Access Compliance Report

Public Rights-of-Way

Intersection ID: 13889	Main Street: DENVIEW_LN	Cross Street: KENHILL_DR	Location: NW
ADA ID: 7B35912047FA	Ramp Type: Directional1	Initial Pass/Fail: Fail	Overall Compliance: No
Severity Score: 1.25			
Codes/Mitigation Info/Possible Solution		Field Measurements/Component Compliance

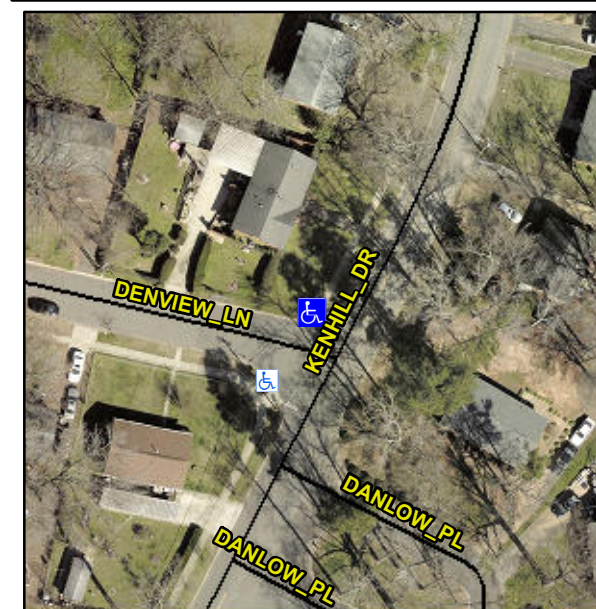
R304.5.3

Remove & Replace Entire Ramp.
